Response to Comments Document

HENRY CORNELL WINERY

Environmental Impact Report
SCH # 2008102040

Prepared for
County of Sonoma Permit and
Resource Management Department

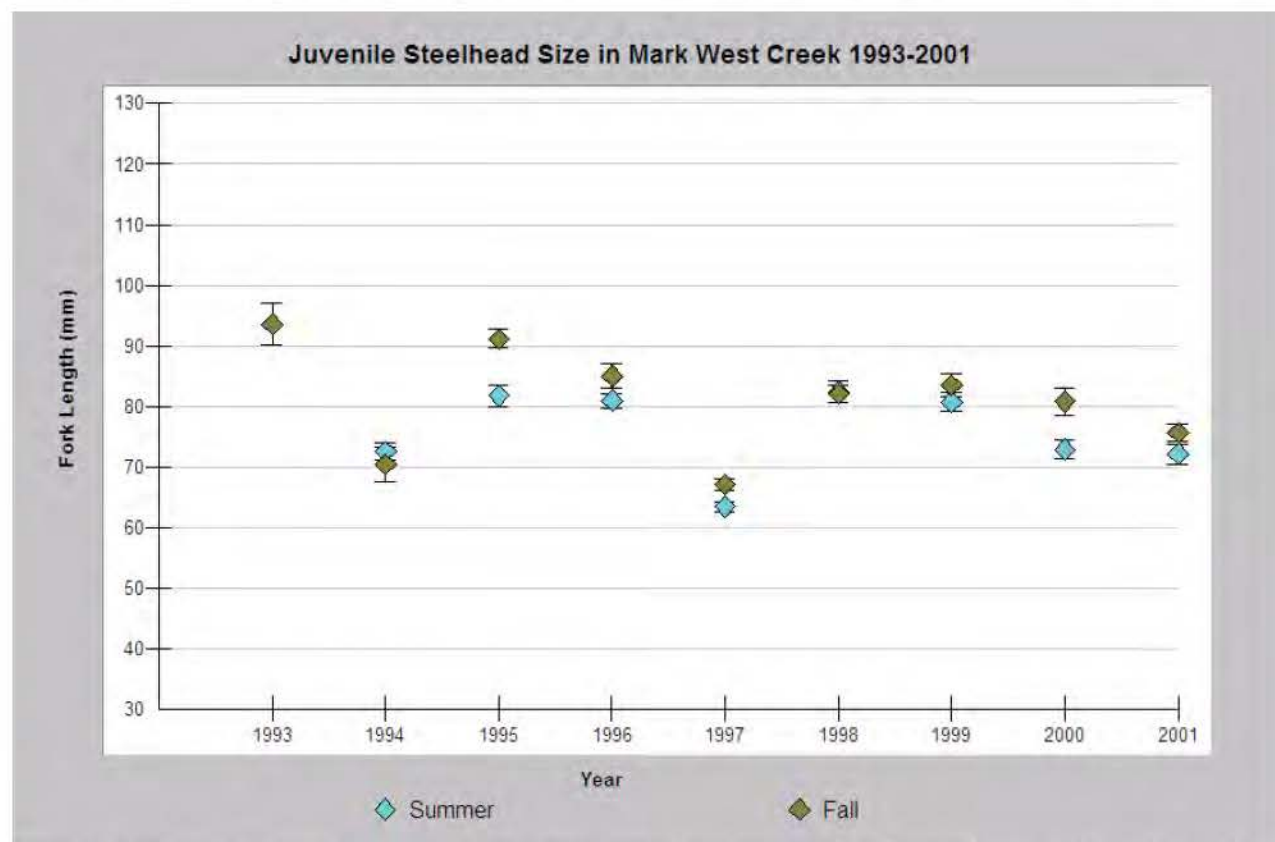
MSC (2002) data also show that there was little growth of Mark West Creek juvenile steelhead between summer and fall from 1993-2001 (Figure 7). Steelhead that are stressed due to warm water conditions or crowded due to diminished habitat related to flow depletion would exhibit such slow growth (Sullivan et al. 2000). Dietrich and Stillwater (2002) found that flows were so reduced in west-side Napa River tributaries that juvenile steelhead became isolated in pools fed by sub-surface flows. While temperatures remained suitable, there was no food delivery and fish marked and recaptured over the summer actually lost weight. This means that, although growth was small or modest depending on flow year in Mark West Creek (MSC 2002), a negative growth can be expected if further flow depletion is allowed.

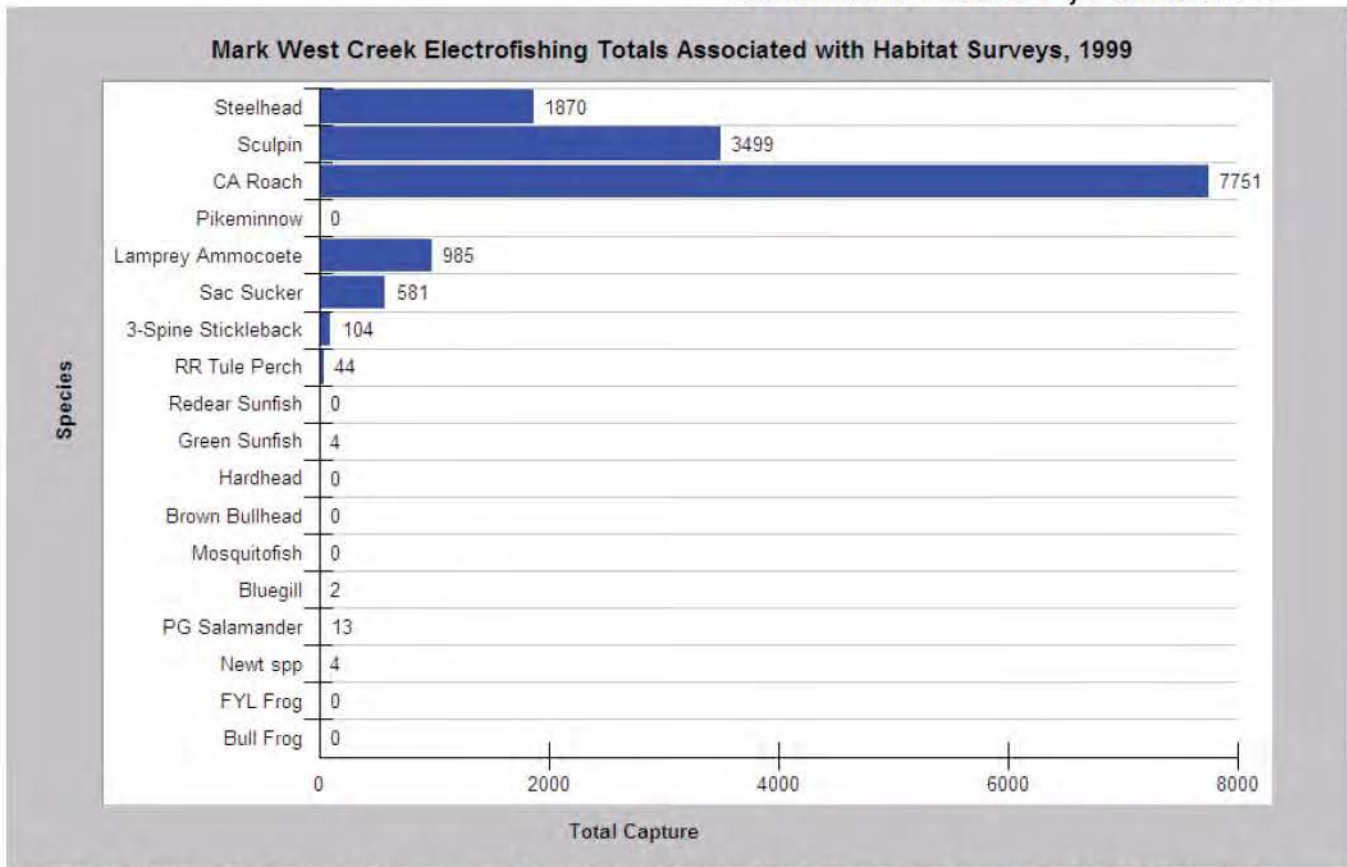
Mark West Creek was extensively surveyed in 2000 by the Sonoma County Water Agency (SCWA) and the catch using electrofishing of representative habitats gives a good picture of the fish community structure (Figure 8). Steelhead remain a substantial component of the community but are fewer in number than other warm water species, such as the California roach. This shift is likely caused by warming that happens in conjunction with depleted flows (see Water Quality) and the historic

Figure 15. Maximum floating weekly average water temperature (MWAT) for 11 mainstem Mark West Creek locations and tributaries Porter, Humbug and Windsor creeks. Data from SCWA and KRIS Russian (IFR 2003).

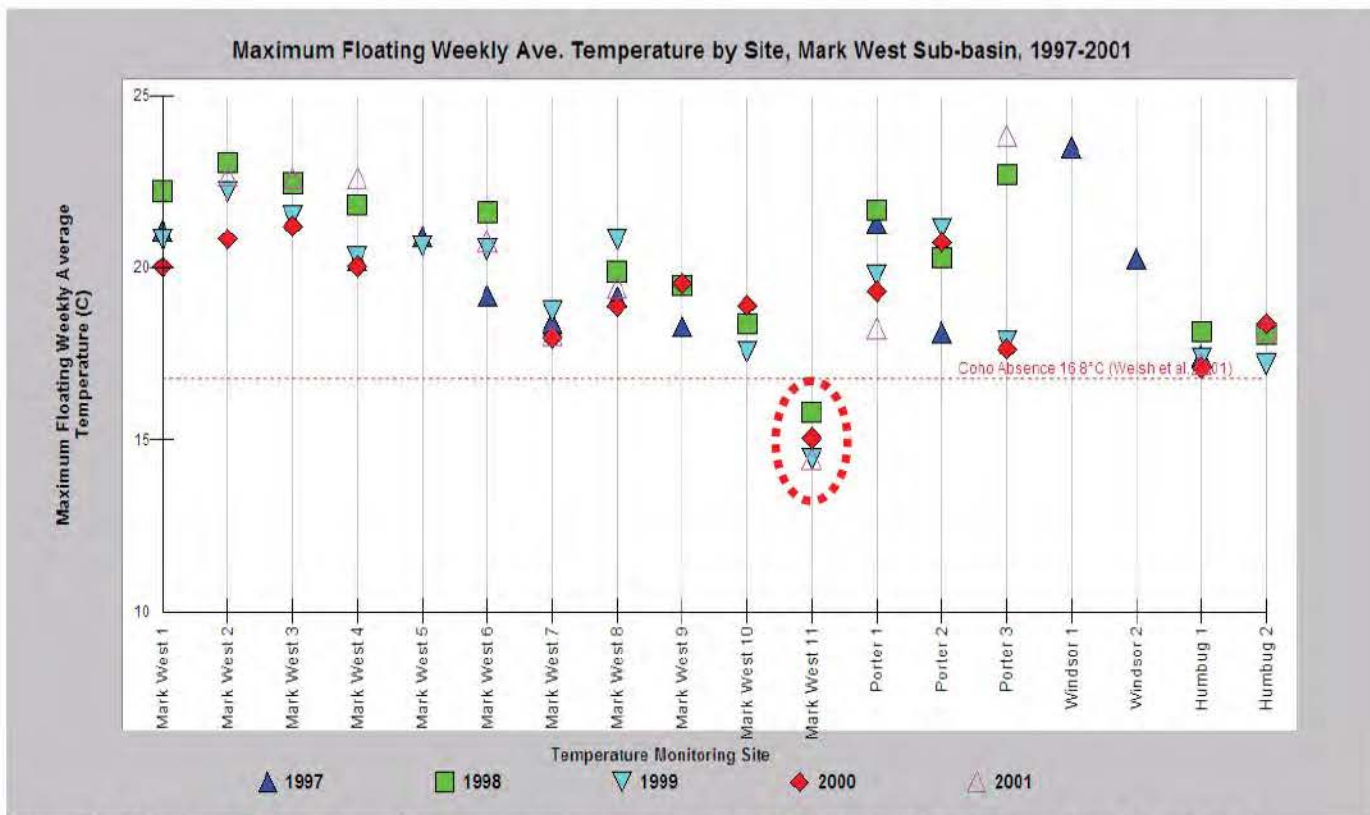
Water Temperature: Water temperature data from various sources (IFR 2003) show that Mark West Creek is highly impaired with regard to its ability to support juvenile coho salmon and steelhead (Welsh et al. 2001, Sullivan et al. 2000). Coho salmon cannot reside in a stream where the maximum floating weekly average water temperature (MWAT) exceeds 16.8^o C or 62.2^o F (Welsh et al. 2001, U.S. EPA 2003). The only Mark West site that is suitable is site #11, which is just upstream of the North Fork (Figure 15-16). Sullivan et al. (2000) found that steelhead growth was suppressed by 10% at 17^o C and 20% when the average temperature exceeded 19^o C. Lower numbered reaches are those further downstream and Mark West Creek increases in temperature in a downstream direction, although this was probably not its historic condition.

Figure 16. This map shows the stations on Mark West Creek and its tributaries and whether temperatures are supportive of coho salmon juvenile rearing. Only Site #11 just above the North Fork had an optimal temperature in all years measured (1997-2001). Data from SCWA and map from KRIS Russian River.

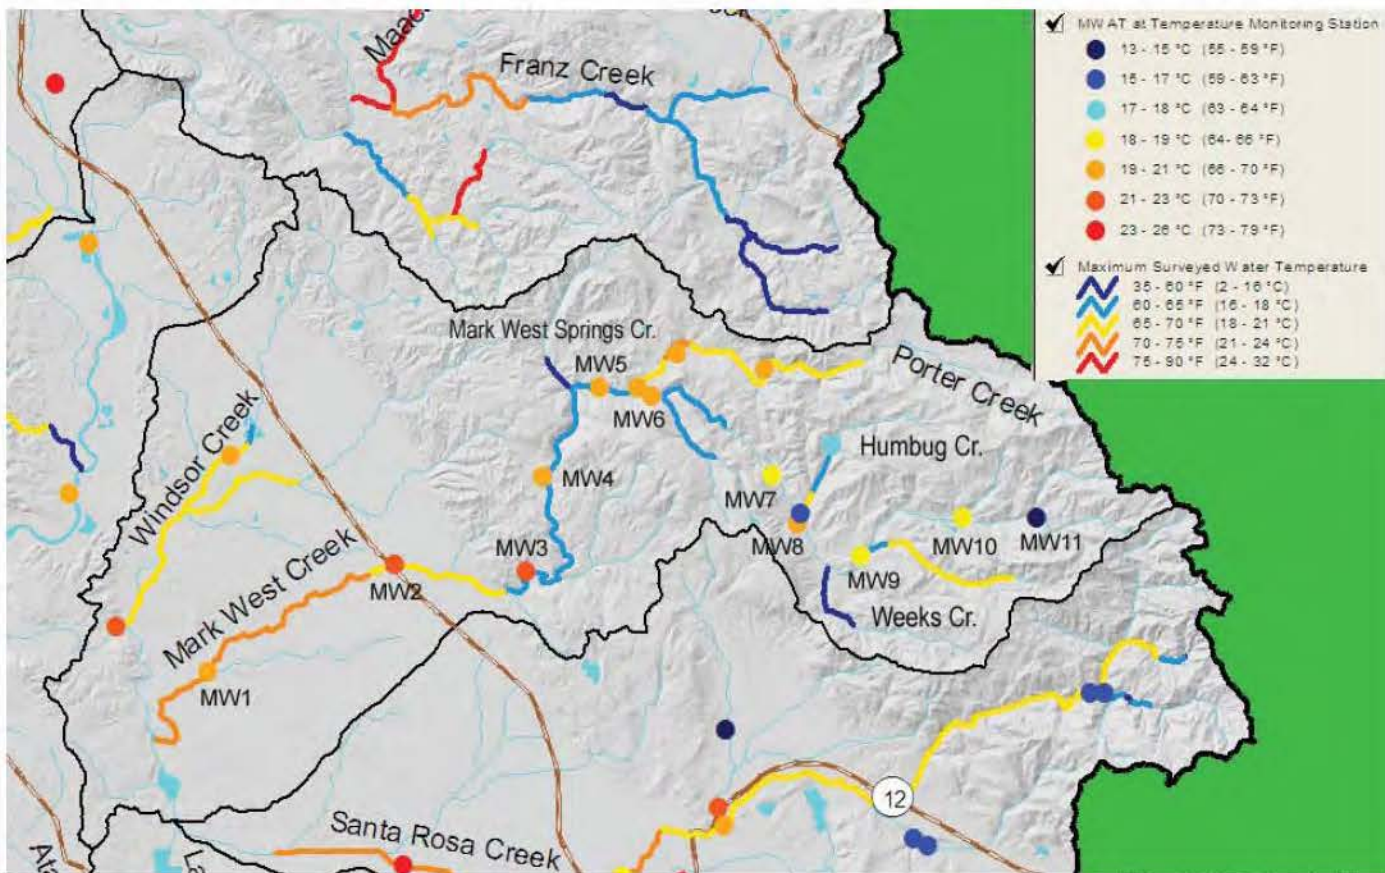
Figure 16 shows ranges of water temperatures in Centigrade (C) by sampling site based on SCWA 1999-2001 data showing the maximum MWAT for all three years. The stream reach overlay is based on data collected during SCWA habitat typing surveys in 1996-1997 and show that Mark West Springs Creek and lower Weeks Creek were suitable for coho salmon. The U.S. EPA (2003) makes the following statement regarding flow volume and water temperature, which applies to Mark West Creek:

The nature of the progressive warming of the mainstem Mark West Creek shown by both data sets in Figure 16 indicates that water temperature is increasing instead of cooling as it once did, because it has become a losing not a gaining stream due to cumulative water domestic and agricultural withdrawals now occurring. While the MWAT is a summary statistic showing the hottest floating weekly average temperature, Figure 17 shows continuous floating weekly average values at various Mark West Creek water temperature sites measured by SCWA in 1999 (IFR 2003). Flows were high and temperatures low in 1999 and the result was water temperature suitable for parts of the summer below Van Buren Creek (MW 9) and downstream of Humbug Creek (MW7). These cold water reaches must be maintained and expanded through implementation of water conservation, if the NMFS (2010) Recovery Plan goal of coho re-establishment between 2009-2019 is to be attained.

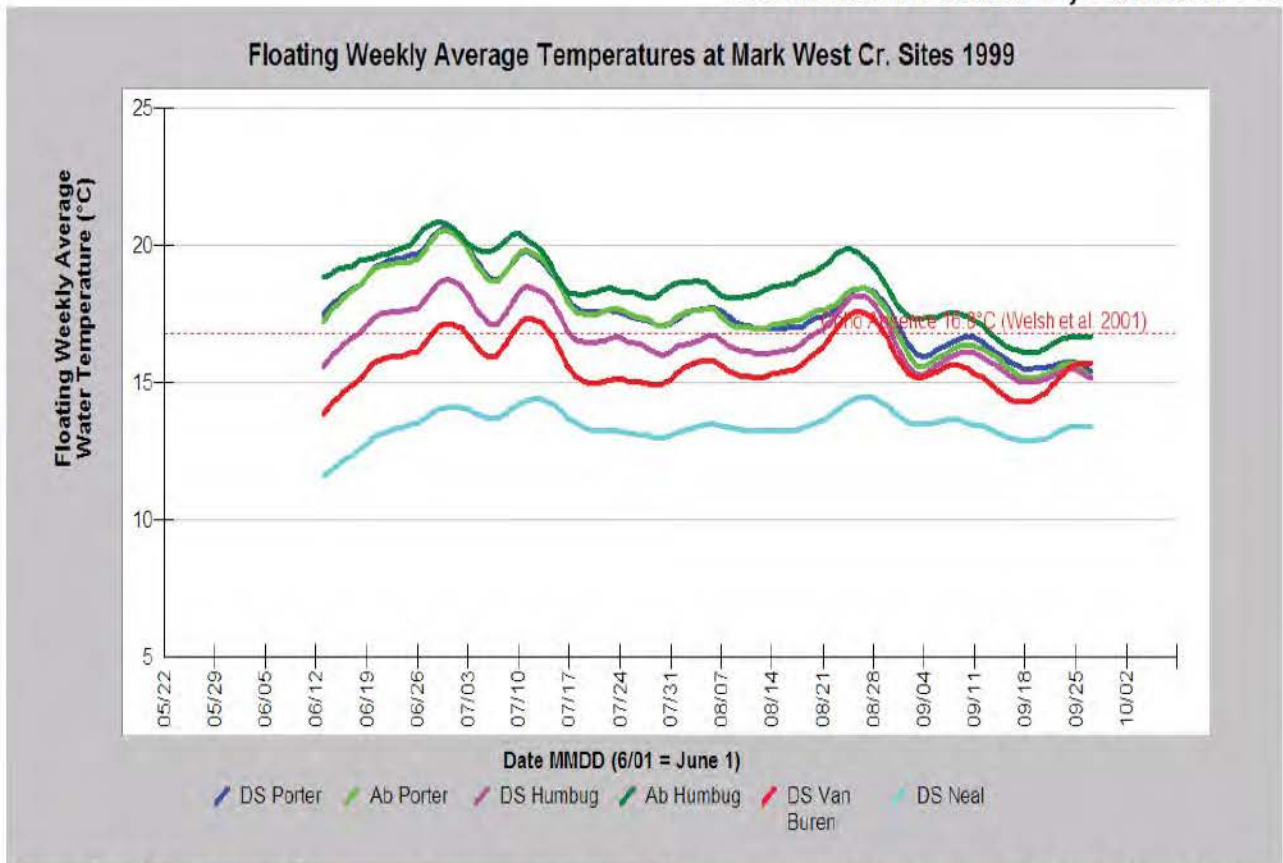
Examination of Porter Creek water temperatures shows that it has a warming influence on the mainstem Mark West Creek (Figure 17). When the floating weekly average water temperature of lower Porter Creek in the years 1999, 2000 and 2001 is analyzed (Figure 18), data show that this reach is above the range of suitability for coho salmon in all years according to regional studies (Welsh et al. 2001). This highlights the importance of the cold water refugia in upper Mark West Creek and the reach immediately below the North Fork. It also shows that there is a need for water conservation implementation in Porter Creek and other efforts like increasing shade to make it suitable for coho salmon being planted there as part of the captive broodstock program as reported by TWA (2011).

Figure 19. Habitat typing data by length for Mark West Creek and its tributaries show four of six reaches that approach 40% pools, but also low pool frequency in some tributaries and extensive dry reaches likely due to flow depletion. Data from SCWA and KRIS Russian River (IFR 2003).

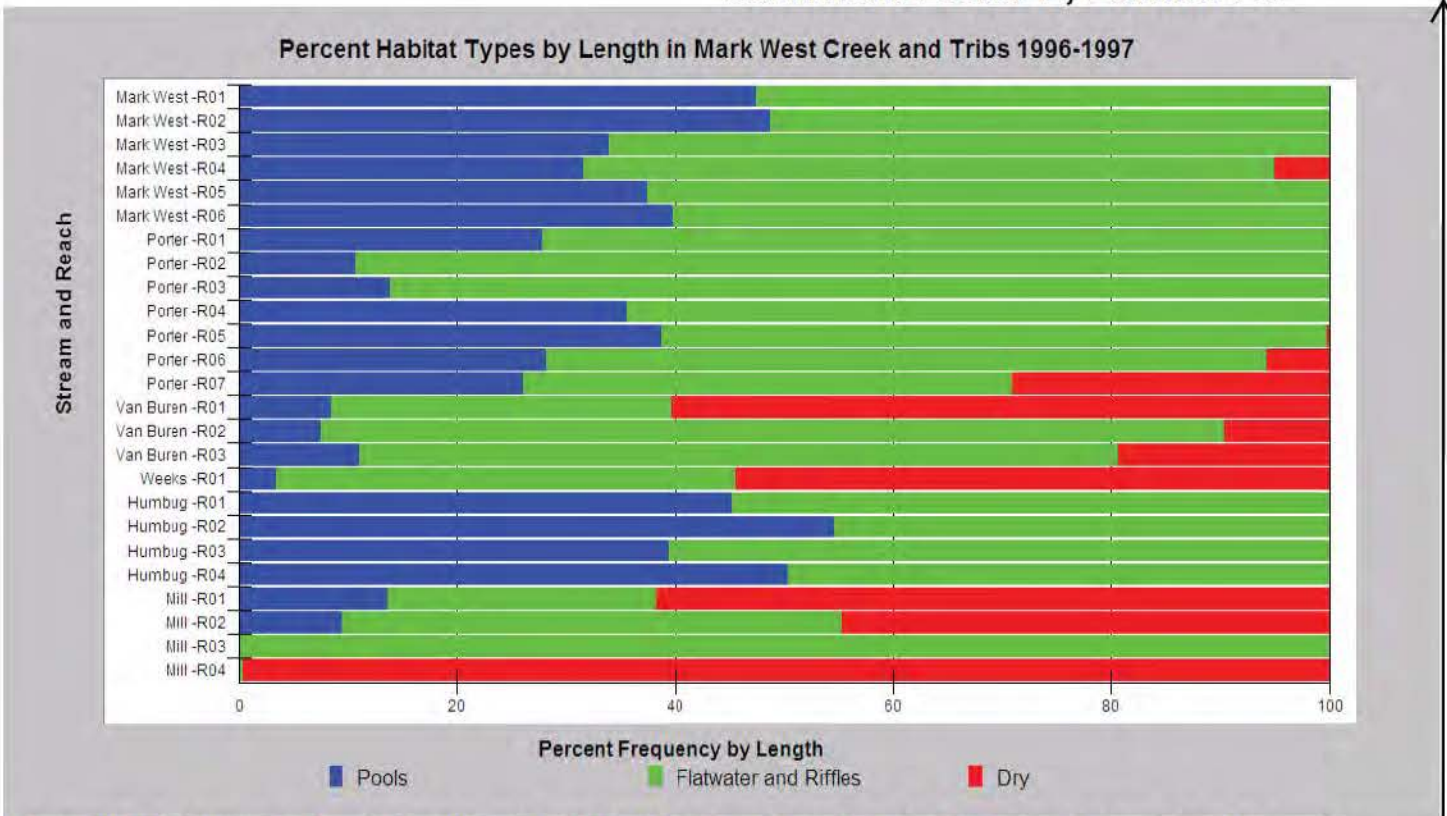
The SCWA conducted habitat surveys of Mark West Creek and its tributaries, Porter, Mill, Van Buren and Humbug creeks in 1996-1997 (Figure 19), according to CDFG (2004b) protocols. Although these data are from approximately 15 years ago, they are still useful in understanding conditions for fish. Pool frequency of 40% by length is considered optimal for salmonid spawning and rearing (CDFG 2004b) and most Mark West Creek reaches were over or near this level (31-48%). However, pool frequency by length in several reaches of Porter, Van Buren, Mill and Weeks creeks were less than 20%, which likely indicates pool filling due to excess sediment contributions. In addition, extensive dry stream reaches surveyed indicate either stream desiccation due to water withdrawal or loss of surface flow due to aggradation or a combination of both. Note that a reach of middle Mark West Creek (Reach 04) also was dry during the 1996-1997 survey. The evidence strongly suggests that these reaches have gone from gaining streams to losing ones due to too much water withdrawal.

Figure 20. Habitat typing data shows pool depth in Mark West Creek with less than optimal pool depths in four of six reaches. Data from SCWA and KRIS Russian River (IFR 2003).

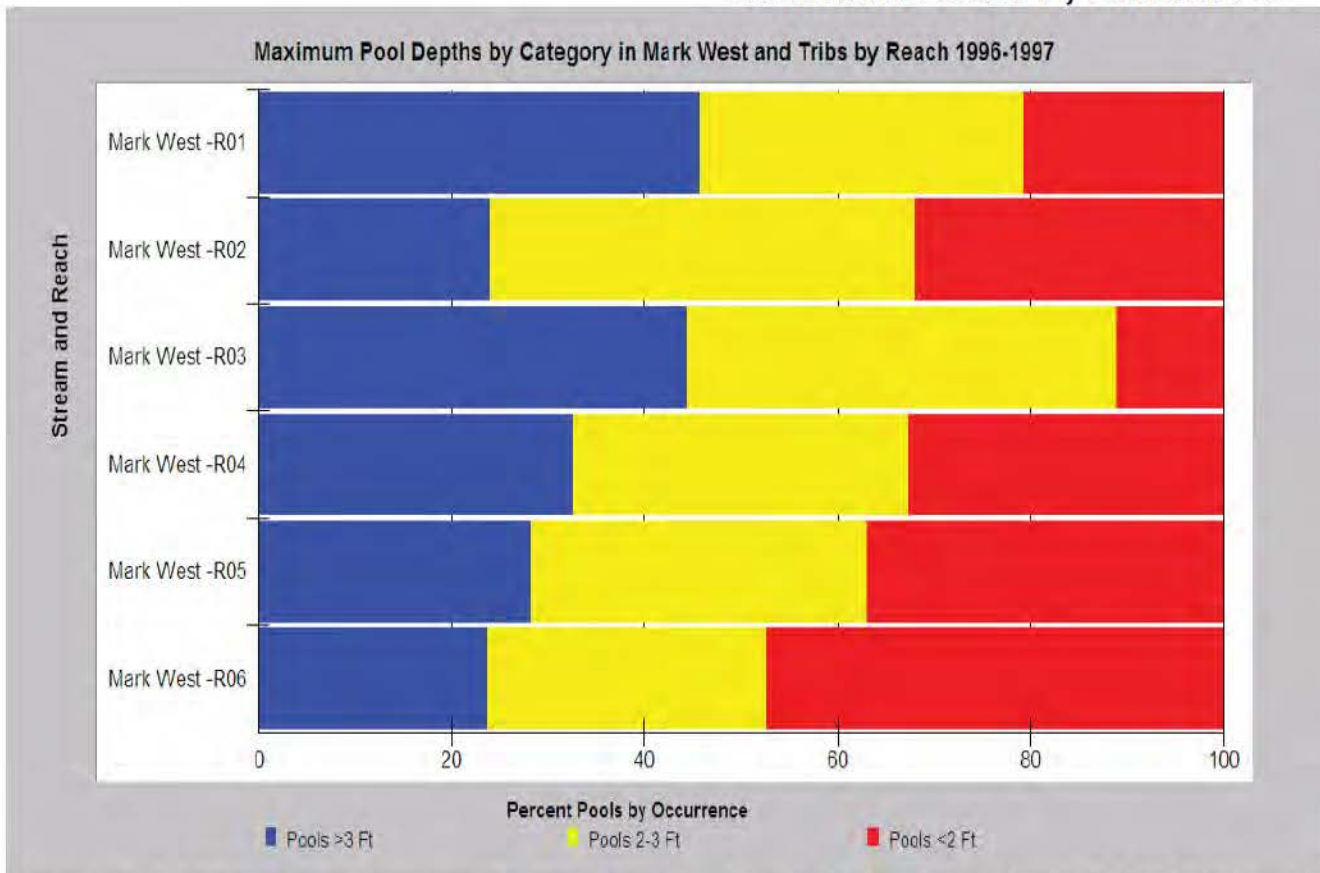
SCWA (IFR 2003) habitat typing data related to pools (Figure 20) shows that pool depths were restricted in the upper-most reach of Mark West Creek, with only 24% deeper than 3 feet and 48% less than two feet deep. Frequency of deeper pools increases in a downstream direction as is expected with increasing stream order, however, the second lowest reach decreases to only 24% of pools over 3 feet deep. This is likely indicative of major cumulative effects as noted by Montgomery and Buffington (1993) where sediment over-supply and/or increased peak discharges related to upstream or upslope land management have caused pools to fill. The problem with the distribution of habitats in Mark West Creek is that the lower reaches where pools are frequent and deep are too warm for coho salmon and older age juvenile steelhead in summer. Upper reaches and tributaries may be cool enough for these at-risk salmonid species, but pool depths restrict carrying capacity. The only way to improve conditions is to restore stream flows in headwaters, not further deplete them and to reduce sediment contributions, which is the opposite of what will occur, if the Cornell Winery Project is approved and constructed.

Plate 1. APPARENT LANDSLIDE SETTING

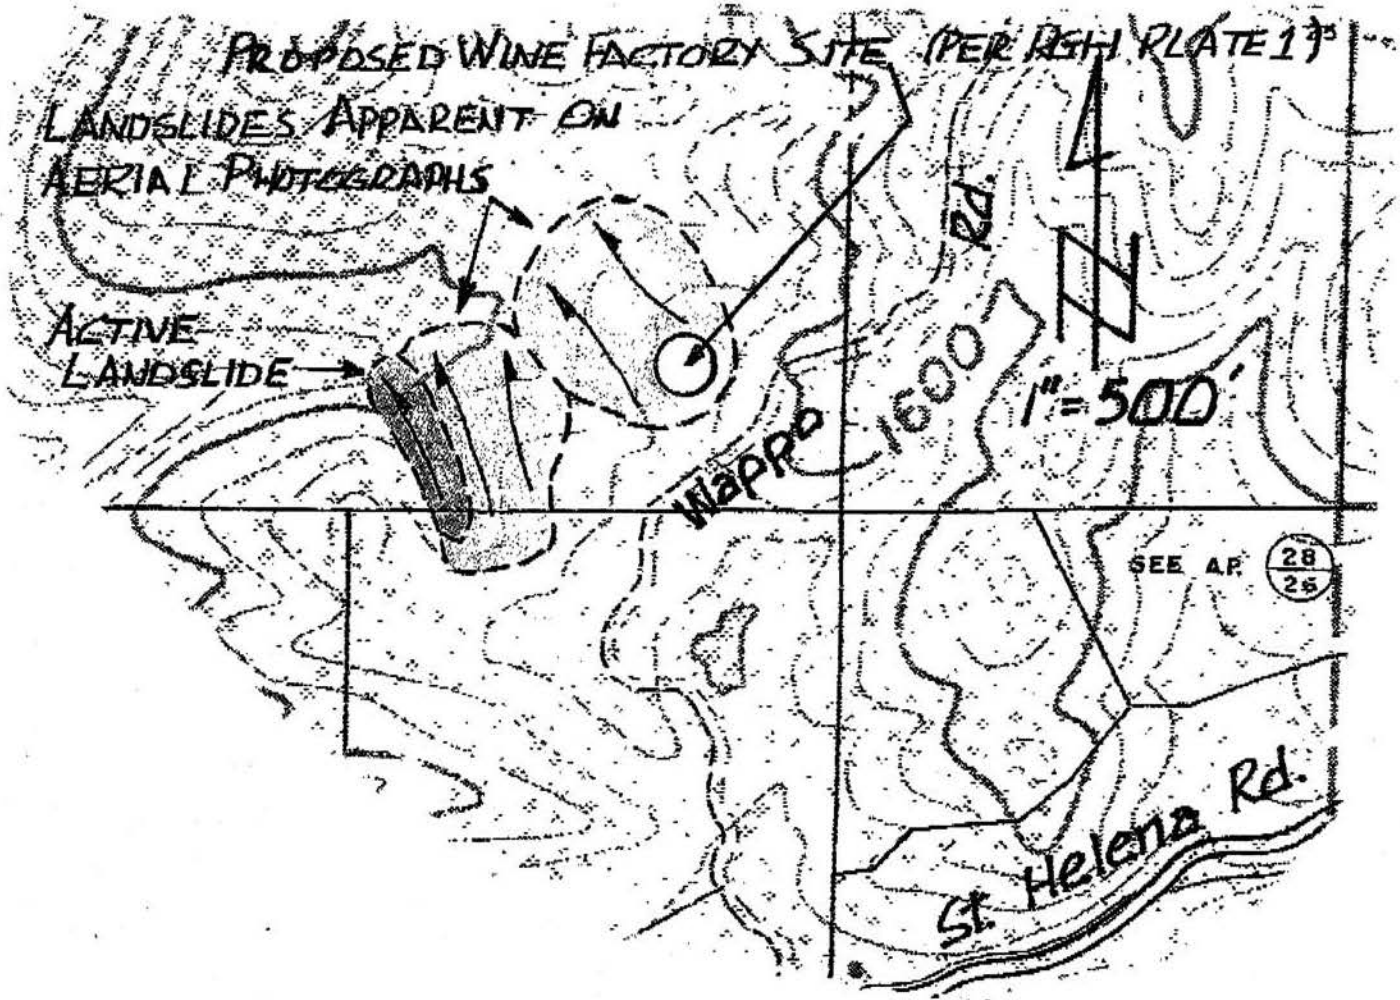
In any event, my field observations and aerial photograph interpretation of landsliding are in very close agreement with the landslide interpretation in Reference 1.
